Access Compliance Report

Public Rights-of-Way (Curb Ramps)

Intersection ID: 54222	Main Street: MIDWAY_PARK_DR	Cross Street: SOUTH_REA_PARK_LN	Location: NE
ADA ID: EB6CCDE14191	Ramp Type: Directional1	Initial Pass/Fail: Fail	Overall Compliance: No
		Severity Score: 1.25

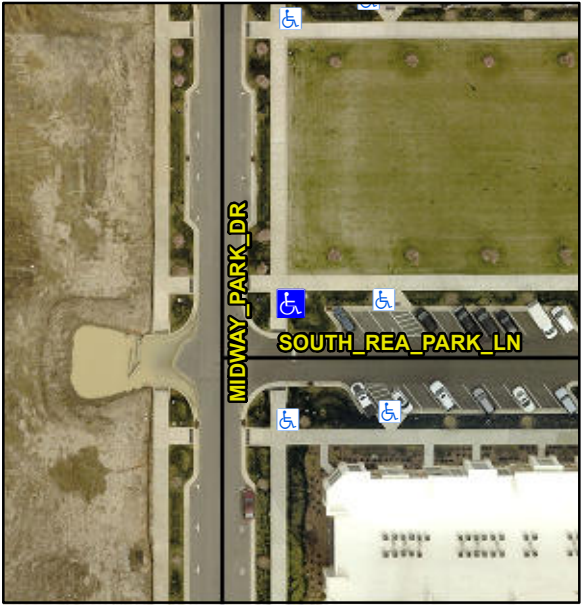
Codes/Mitigation Info/Possible Solution			Field Measurements/Component Compliance		
	Possible Solutions:		Compliance	Description	Data
	Remove & Replace Entire Ramp.		N/A	Ramp Length (in)	97.5
			Yes	Ramp Width (in)	94.0
			Yes	Ramp Slope (%)	4.2
			No	Ramp XSlope (%)	2.1
			N/A	Flare Type LT	N/A
			N/A	Flare Slope LT (%)	N/A
			N/A	Flare Traversable LT?	N/A
			N/A	Landing Length (in)	0.0
			N/A	Landing Width (in)	0.0
<p>Surveyor Notes:</p> <p>N/A</p>			N/A	Landing Slope (%)	0.0
			N/A	Landing X Slope (%)	0.0
			N/A	Landing Curb? (Y/N)	N/A
			N/A	Shared Landing?	N/A
			N/A	Gutter Ponding?	0.0
			N/A	Gutter Lip Ht (in)	0.0
			N/A	Painted X Walk1?	No
				X Walk 1 Direction	To S
				X Walk 1 Width (in)	N/A
				X Walk 1 Slope (%)	1.7
<p>PROW/ADA:</p> <p>R304.5.3</p>				X Walk 1 X Slope (%)	3.7
			N/A	Ramp inside XWalk1?	N/A
			N/A	Any Obstructions?	N/A
				Obstruction Type	
			Yes	Surface Condition? (G/P)	Good
			N/A	Curb Slope (%)	11.7
